Submission - DA2022/005 - 21 Moore Street Clontarf NSW 2093

Submission in respect of DA2022/0005 - 21 Moore Street Clontarf NSW 2093

View from living room as extracted from Realestate.com on 6 February 2022 showing the true view which will be impacted

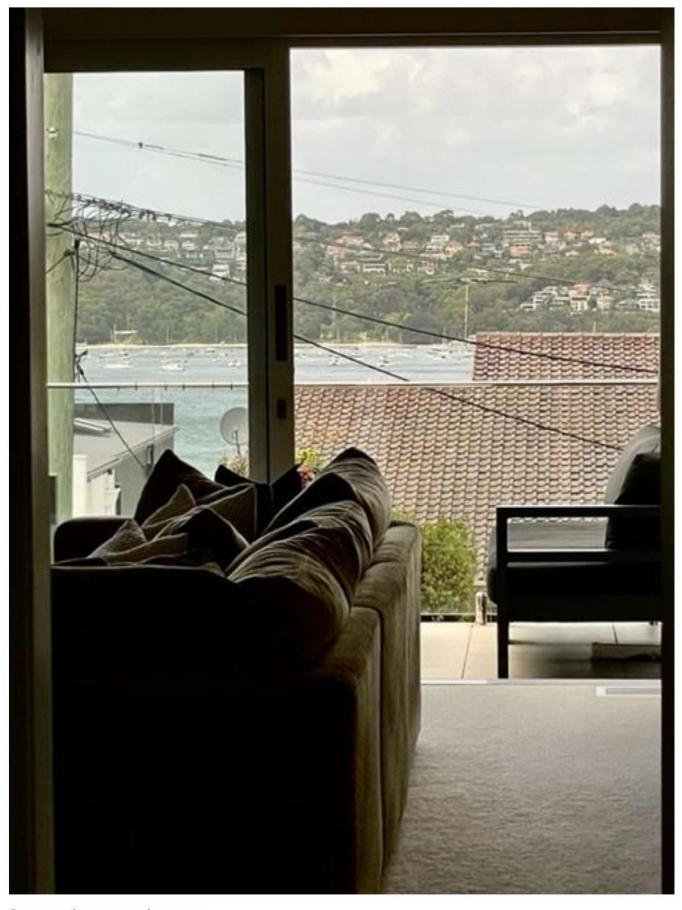
The same website from which the Figure 15 photo was extracted shows the view from the living room (reproduced below) and so I can only assume Figure 15 was selected to support the argument as opposed to fairly representing the impact of the proposed roof line change.

As can be seen from the photo below that Watermark could have accessed, by filling in the roof line of 21 Moore Street (the roof is to be "squared off" as they describe it) up to 50% of the views of Balmoral Beach will be lost from a standing position in my living room.

How this can be termed as negligible is difficult to understand.
